ADA Curb Ramp New Construction Inspection Form (Parallel)

NW Main

23885.56

NW Lenox

PARALLEL RAMP (PL)

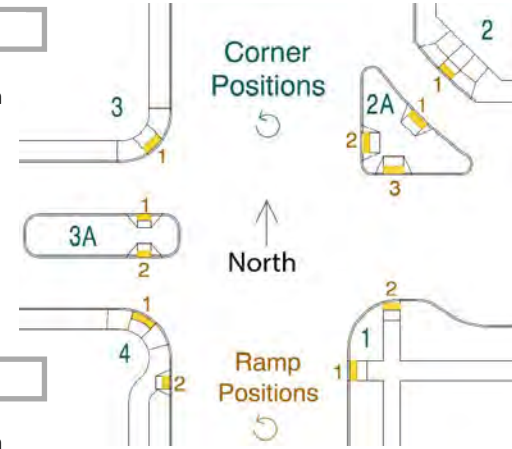
5.3 $\leq *$ ☐ $> *$ ☒

6.9 $\leq |5.0\%|$ ☐ $> |5.0\%|$ ☒

11.1 $\leq 8.3\%$ ☐ $> 8.3\%$ ☒

DWS IITD Fails RR 1
